**Champlain Hudson Power Express (“CHPE”)
Environmental Management & Construction Plan
Notice of Major Change**

Project: Champlain Hudson Power Express

Segment: 10

Notice Number: 196

PERMIT DRAWING NO. N/A DRAWING NO. G-017

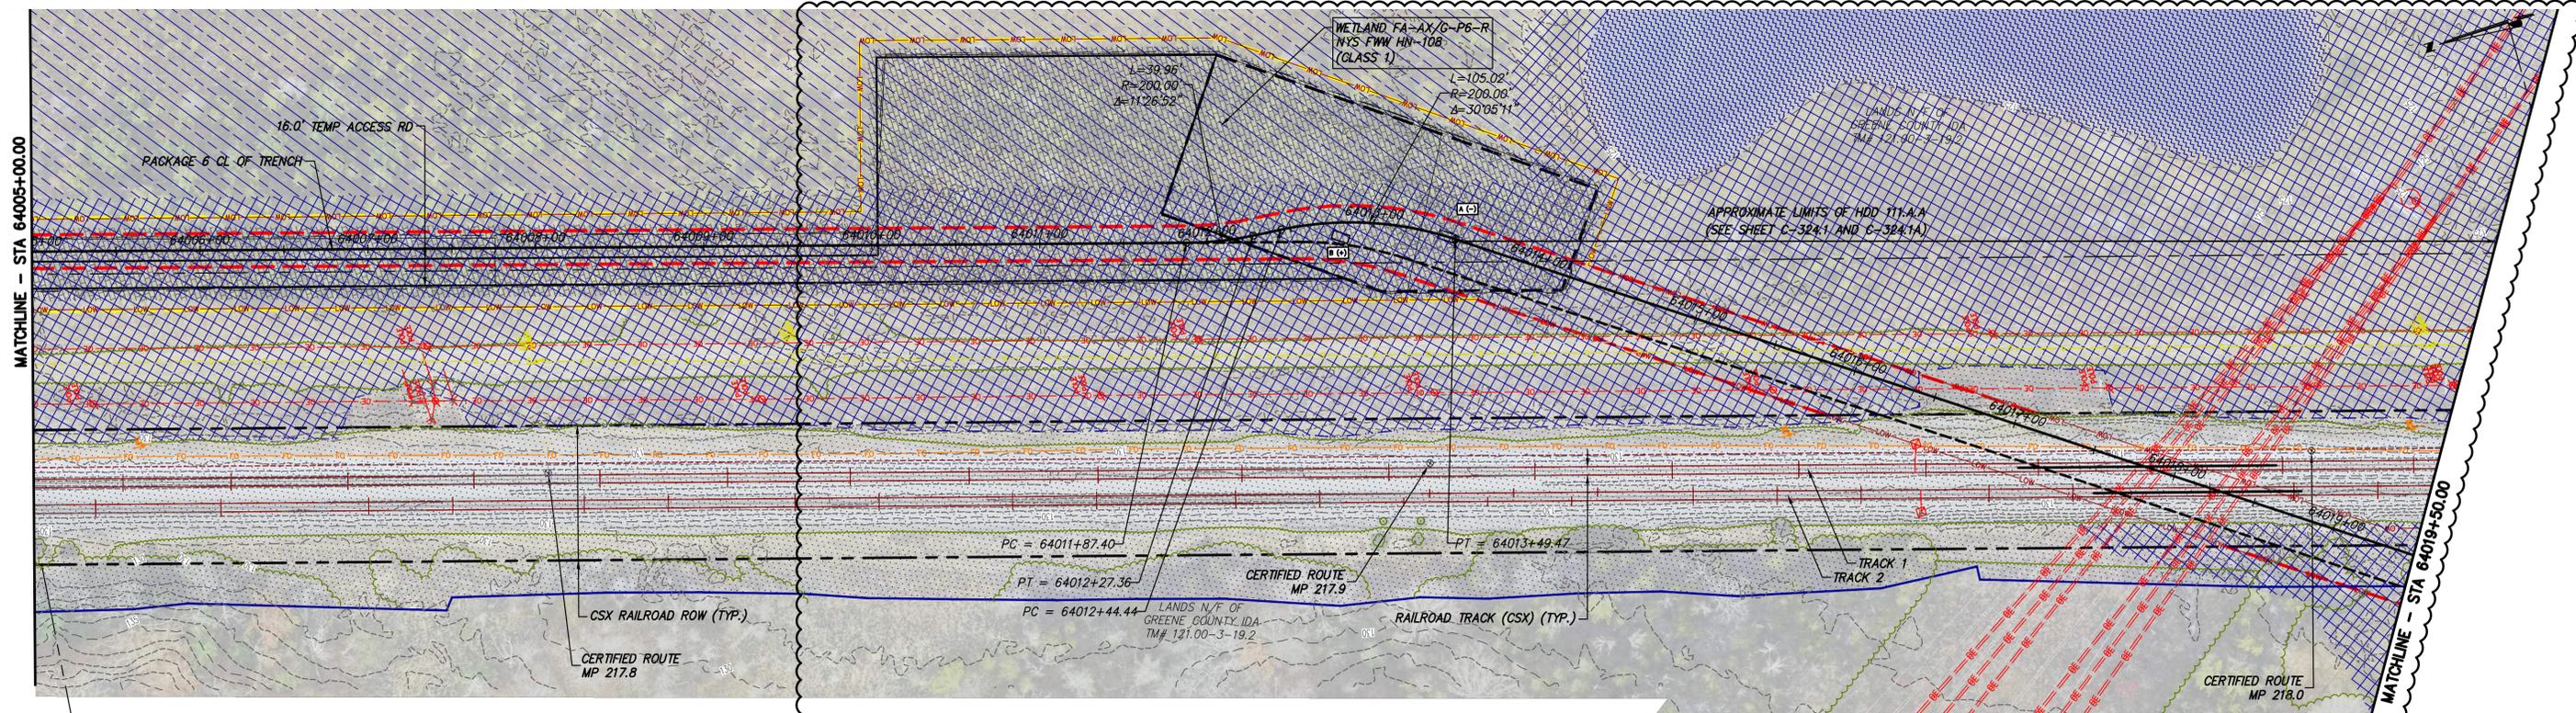
G-017	1	NDC-0050: Leeds Athens Reroute	Update of Ag Land table to remove parcels no longer impacted, update of Railroad crossings to include new crossing
C-168	1	NDC-0050: Leeds Athens Reroute	Update plan and profile to incorporate the new HDD 111.A.A design
C-169	1	NDC-0050: Leeds Athens Reroute	Update plan and profile to incorporate the new HDD 111.A.A design, revised splice 228 location, and alignment shift to west side of the CSX tracks
C-170	2	NDC-0050: Leeds Athens Reroute	Update plan and profile to incorporate the alignment shift to west side of the CSX tracks
C-171	1	NDC-0050: Leeds Athens Reroute	Update plan and profile to incorporate the revised splice 228A location, and alignment shift to west side of the CSX tracks
C-172	2	NDC-0050: Leeds Athens Reroute	Update plan and profile to incorporate the alignment shift to west side of the CSX tracks
C-173	2	NDC-0050: Leeds Athens Reroute	Update plan and profile to incorporate the revised splice 229 location, and alignment shift to west side of the CSX tracks
